Inspection Report Repair List: 1311 W Bell , Houston, TX 77019

QUALITY OF WORKMANSHIP INSPECTION REPORT

Mr. Geoff Berg
1311 West Bell Street
Houston, Texas
December 1, 2020

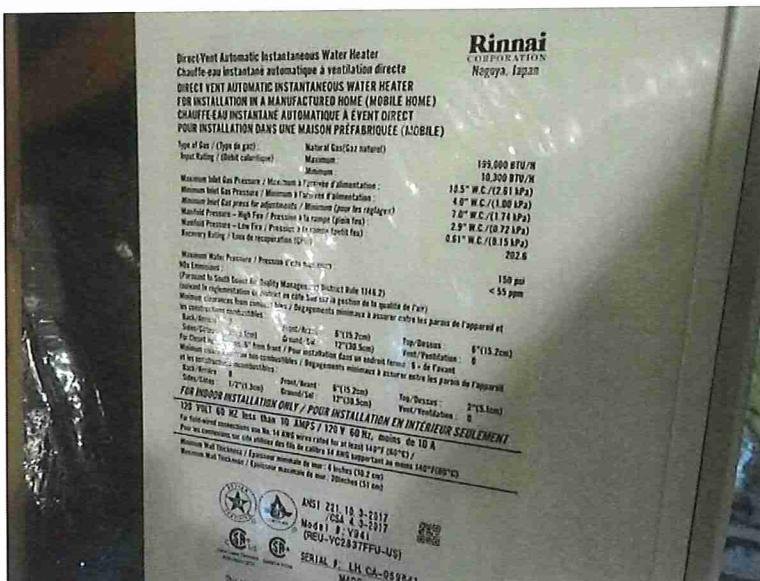
1. The roof head flashings had fasteners driven exposed in the lower surfaces to hold the flashing down against the roof. If the flashings had been properly constructed, there would have been no need for fasteners in the exposed surfaces of the flashings. As a minimum, the heads of the fasteners should be covered with a high quality caulk.

2. There appeared to be damage to the metal roof jack used at the furnace flue penetration at the attic, which could allow water penetration into the attic and should be replaced.

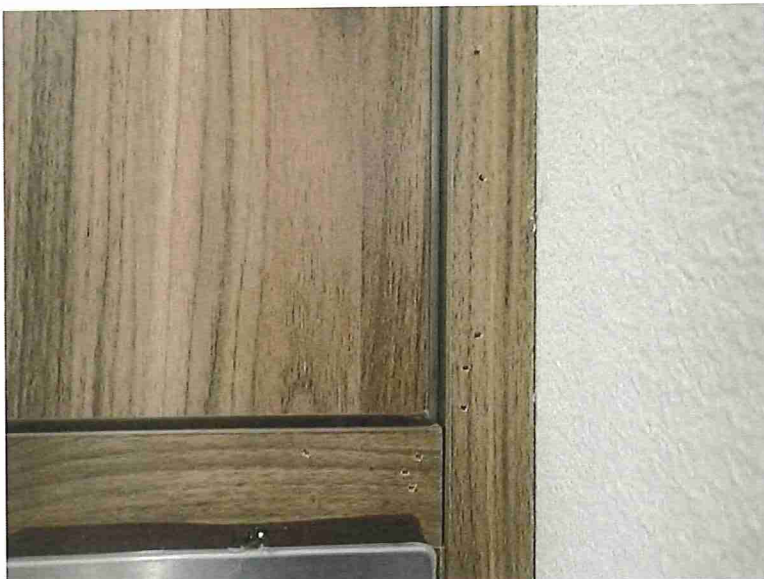
3. Hot water for the building was provided by a single on-demand gas-fired water heater having a maximum input capacity of 199,000 BTU/hr. Determining the adequacy of the water heater was beyond the scope of this inspection and should be designed based upon the maximum flow anticipated and the required temperature rise for an on-demand water heater. The equipment appeared to be of a size typical {...full text in report}

4. The 1/2 bathroom ventilator fan outlet had a bent damper and did not close tightly against the damper, and the vent flue was not flashed to the water-resistant barrier. Because the hood is not flashed to the water-resistant barrier, this increases the potential for water entry and may result in energy loss since the damper does not close tightly.

WT

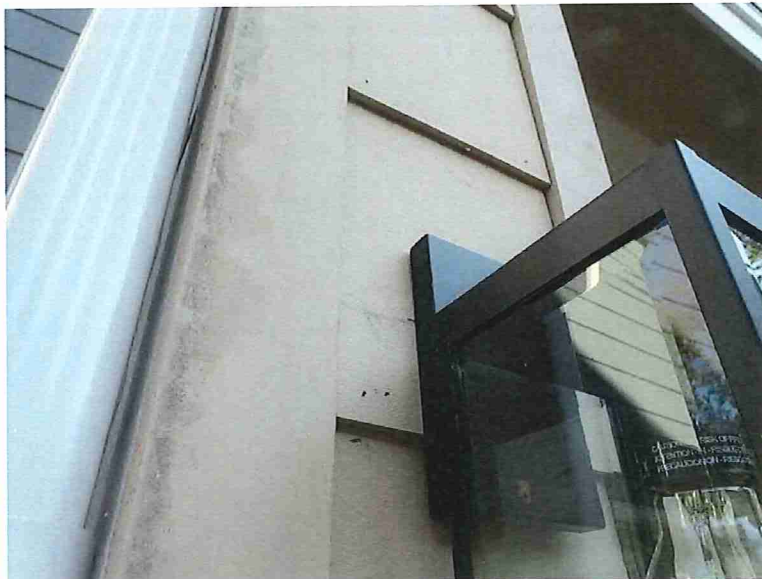
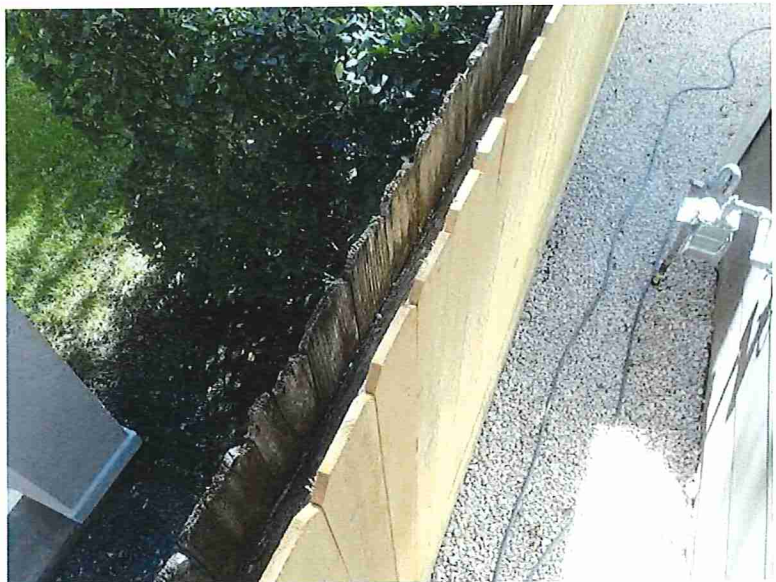
5. The area vent for the 1/2 bathroom did not appear to fully penetrate through the exterior wall, as observed at the vent hood opening.

6. Cabinet facings around the oven and microwave oven had been installed with fasteners driven through the face of the facings that were prefinished. This creates an irregular appearance that may not be repairable without replacement of the facings.

7. Insulation in the attic space was measured to be less than the R=38 specified on the data tag in the attic and the R=30 specified on the data tag at the panel box. R=38 is the minimum prescriptive depth of insulation acceptable in the Houston area, and there is an apparent need to add insulation at the attic.

Y

C

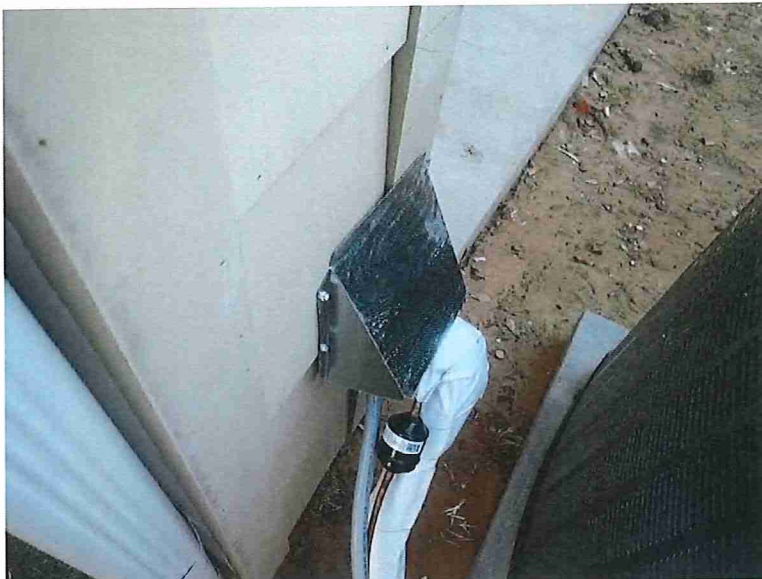
8. It appeared pickets at the east fence were applied to old fencing. It is possible that the fence frame may deteriorate before the pickets.

9. It appears finish nails had been used to secure some siding at the south side of the building. Nails could be observed at other locations. Finish nails are not considered an acceptable fastener for securing siding.

10. Penetrations through the fiber cement siding visible along the east side of the building were apparently made without adequate flashing to the water-resistant barrier behind the siding. The rough edges of the sheathing were visible around some penetrations. This increases the potential for water entry and is generally difficult to properly repair without removal of siding materials.

Y

Y

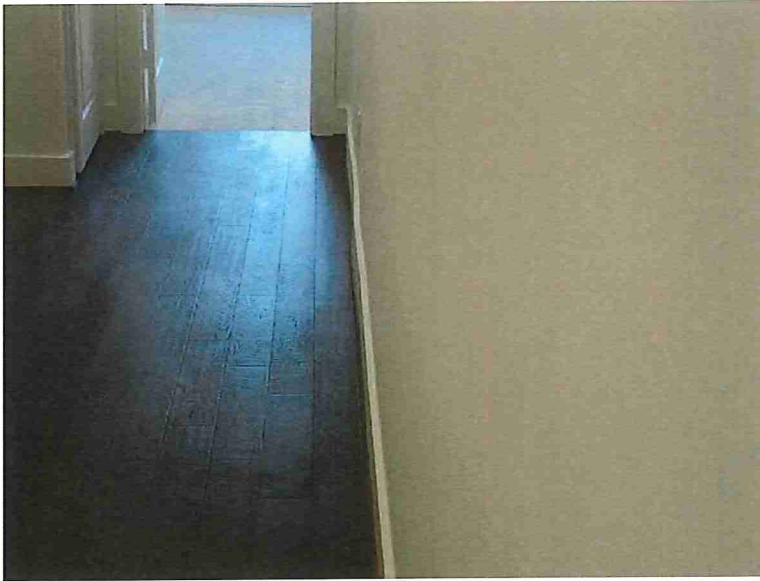
11. Soffit finishes were incomplete at the front porch and rear porch areas. The drywall ceiling covering at the rear porch appeared to be a mix of fire-rated sheetrock and exterior-rated sheetrock rock. Exterior-rated sheetrock is normally used at exterior locations.

12. The air conditioning flashing hood did not extend behind the siding to the water-resistant barrier. This could leave the opening without adequate flashing that could allow water entry to the wall structure at the condensing unit.

C

N

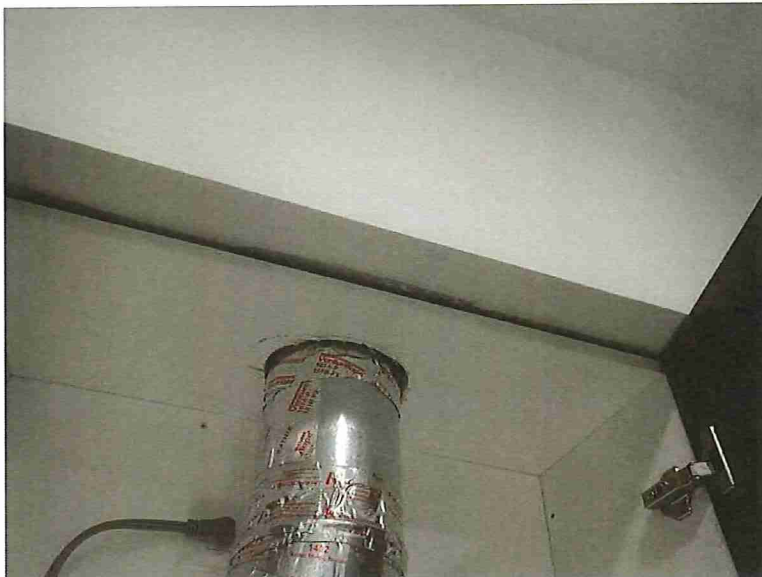
- 13. The base trim was uneven along the east side of the upstairs hall adjacent to the master bathroom, creating a poor appearance.

- 14. The fit of the floor tiles at the master bathroom shower enclosure was poor in appearance, where there were irregular tile joints and poorly cut tiles.

- 15. The furrdown finish was incomplete over the cabinetry at the upper cabinets at the kitchen. It appears that a valance may be missing or that the cabinets may have been installed too close to the furrdown since the cabinet doors dragged the furrdown. There may be a need to reset the cabinets lower with a valance to improve the performance and appearance.

16. The gutter system at the west side of the building adjacent to the upstairs hall bathroom area was partially crushed, apparently due to a lack of adequate clearance to the adjacent unit. This will reduce its cross-sectional area and increase the potential for it to become clogged. This may increase the need for cleaning. Access to the gutters appears to be only from the roof and will be difficult.

17. The joint cuts in the siding trim components were not made at 45-degree angles, typically intended to maintain alignment and create a good appearance. Because the cuts were made at 90 degrees, they were uneven at some locations around the building, creating a poor appearance.

N

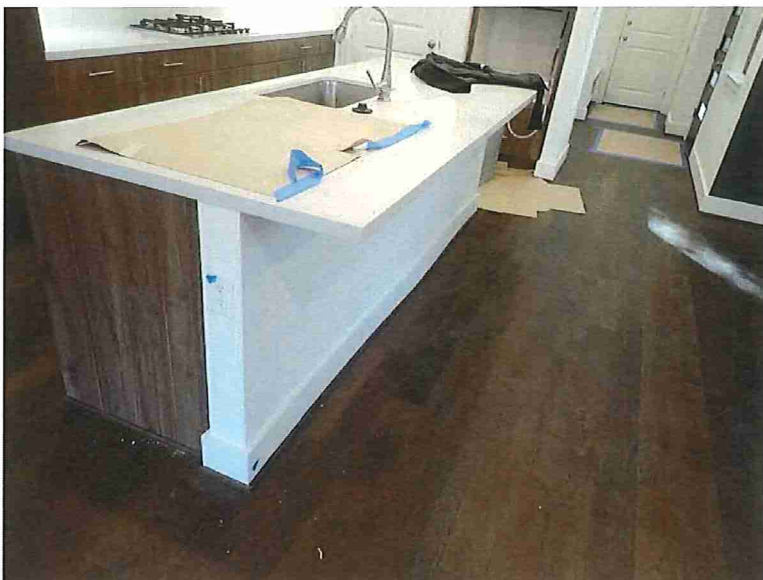
18. The newel posts at the base of the stairs had a poor quality finish, where it appears filler was used, creating an irregular appearance.

19. The window stop was missing at some windows, including at the master bedroom. The window stops are intended to prevent the windows from fully opening to prevent persons from falling out of them.

C

Y
